NATIONAL DAM INSPECTION PROGRAM. LITTLE YOUGHIOGHENY RIVER SITE--ETC(U)

LITTLE YOUGHIOGHENY RIVER SITE NO. 7

NDI ID NO. MD 32

PHASE I INSPECTION REPORT

LITTLE YOUGHIOGHENY WATERSHED
GARRETT COUNTY, MARYLAND
RESERVOIR NO. 7
DETAILS OF SEEPAGE DRAIN
U. S. DEPARTMENT OF AGRICULTURE
SOIL CONSERVATION SERVICE

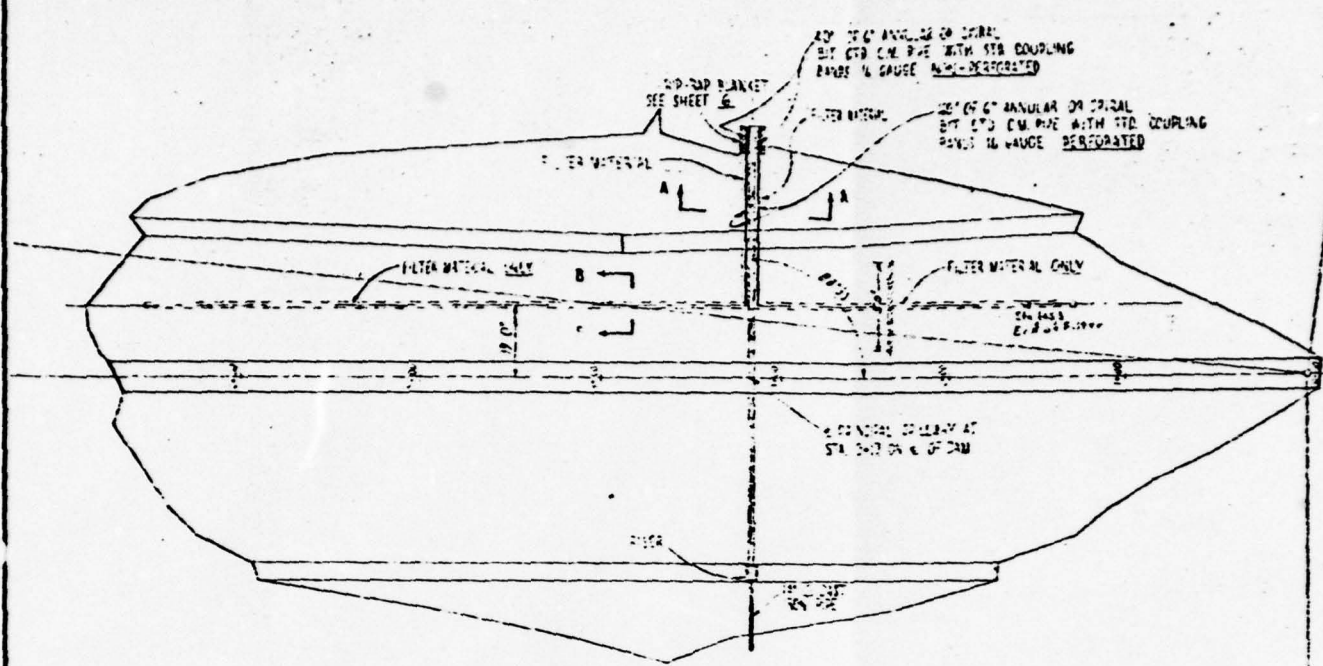
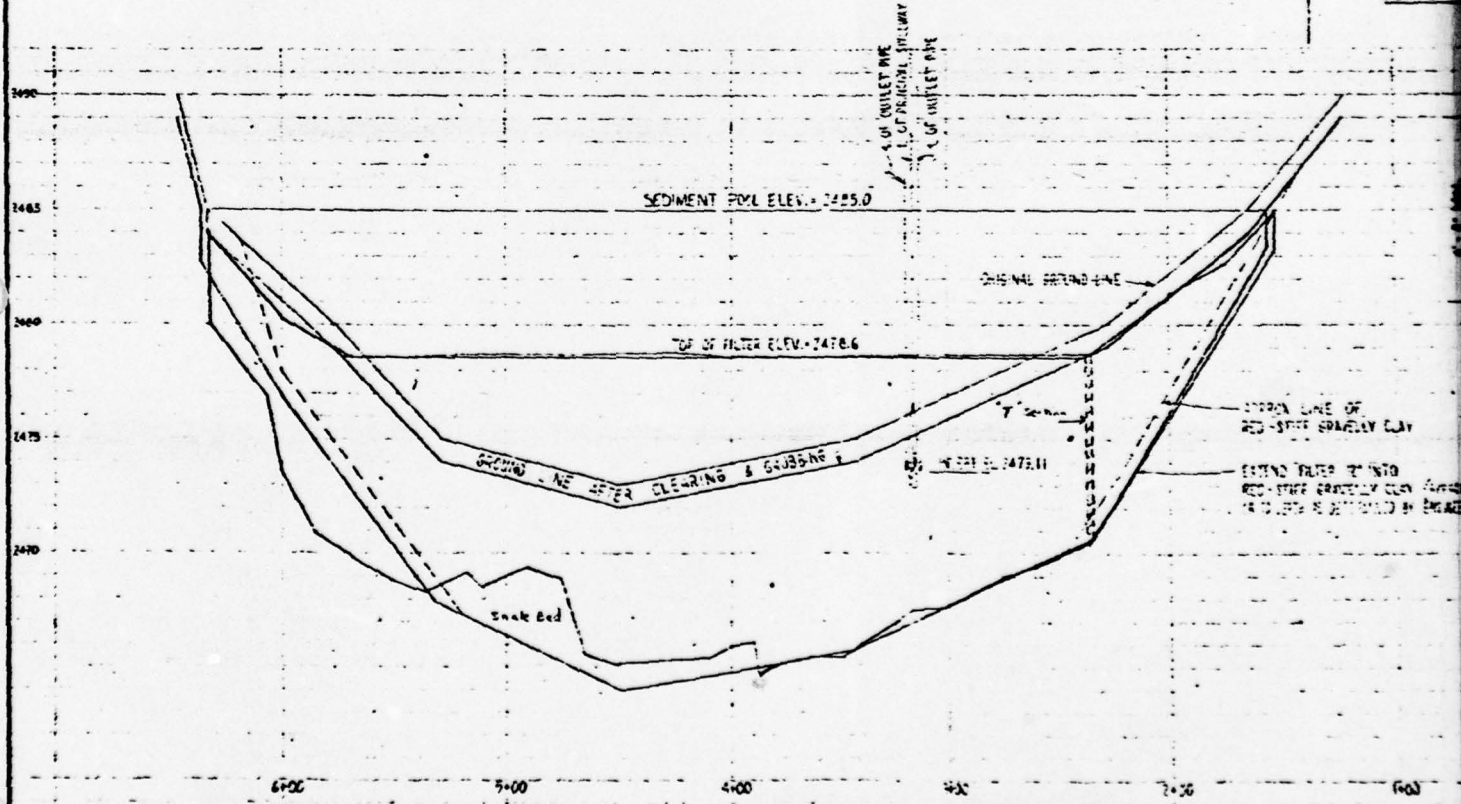
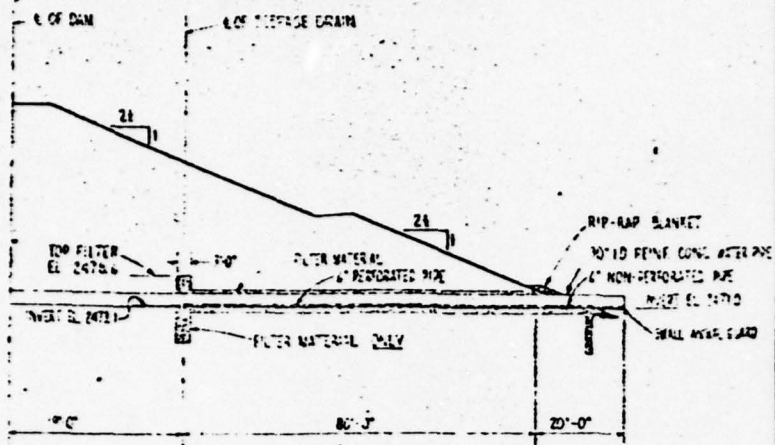
On the date of the field reconnaissance review, the outlet drain pipes were observed inundated by tailwater. The exposed bottom of the south outlet toe drain was observed rusted through. This outlet toe drain was reportedly accidentally damaged by Soil Conservation Service inspection personnel about two weeks later.

Deposited plunge pool bank material should be removed from the downstream channel to reduce the risk of inundating outlet toe drains. Should the outlet toe drains become obstructed or inundated by tailwater, a significant rise in the downstream embankment phreatic surface may develop and reduce embankment stability.

2) Remove damaged end section of seepage outlet drain pipe. Replace with new pipe end section and connecting band or install a perforated plastic pipe inside remaining outlet pipe sections.
